STAFF REPORT
(PRELIMINARY PLAT)

CASE NUMBER: SUB 2002-144 – AVALON PARK ADDITION

STAFF REPORT

(FINAL PLAT, PRELIMINARY PLAT APPROVED 1/16/03)

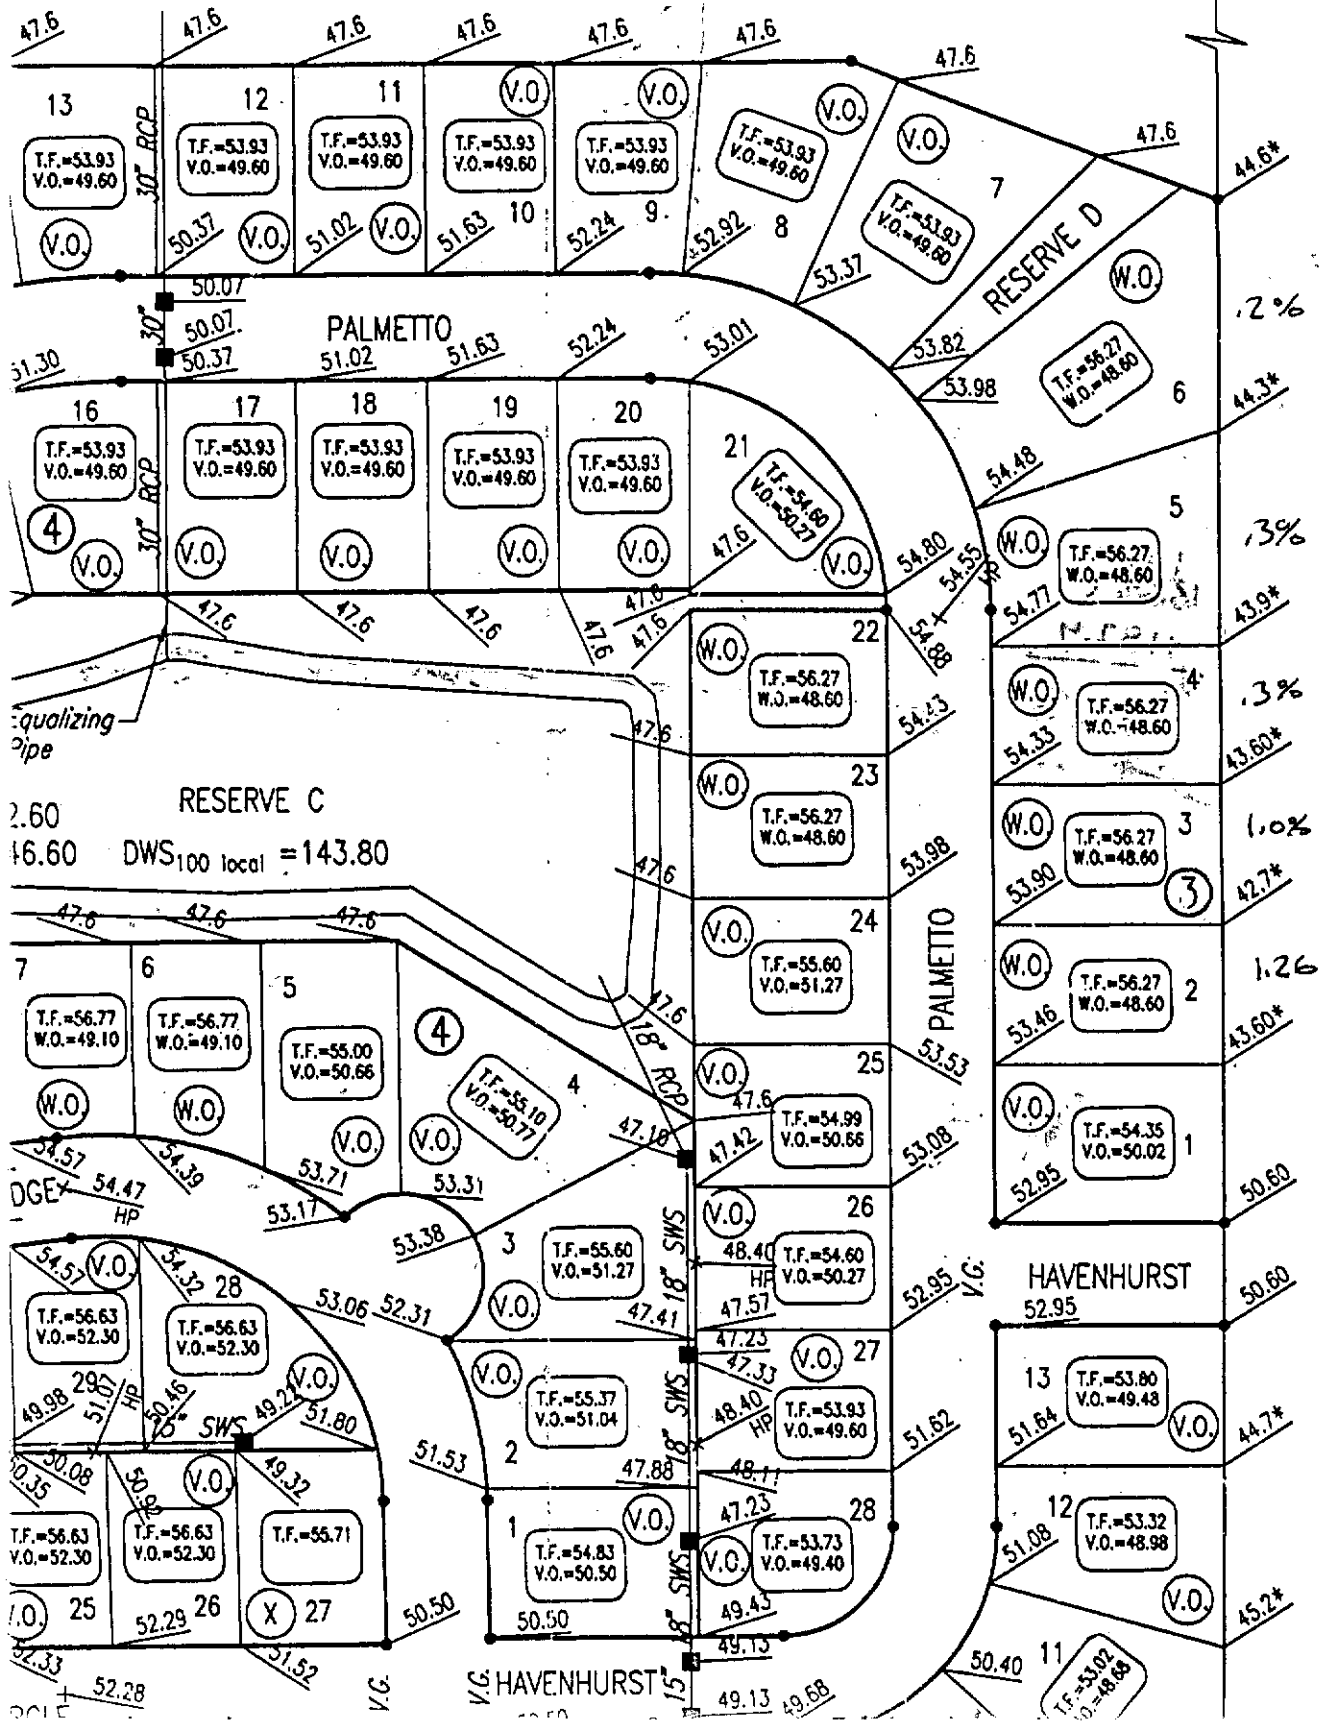
It has come to our attention that the Lots 1 – 6, Block 3, Avalon Park Addition are still in the floodplain. We have placed a hold on all building permits for these lots until FEMA removes the property out of the floodplain. There is also concern regarding the rear lot grading, as it does not meet the minimum subdivision grade requirement of one percent.

At the present time, the City has a contract for a storm water sewer project that we are preparing to close. I understand that staff had at one time proposed a change order to the project to help rectify the current plan deficiency in lot grading, but that you were unwilling to do so. Therefore, we will proceed to close the project out unless I hear differently by you within seven days.
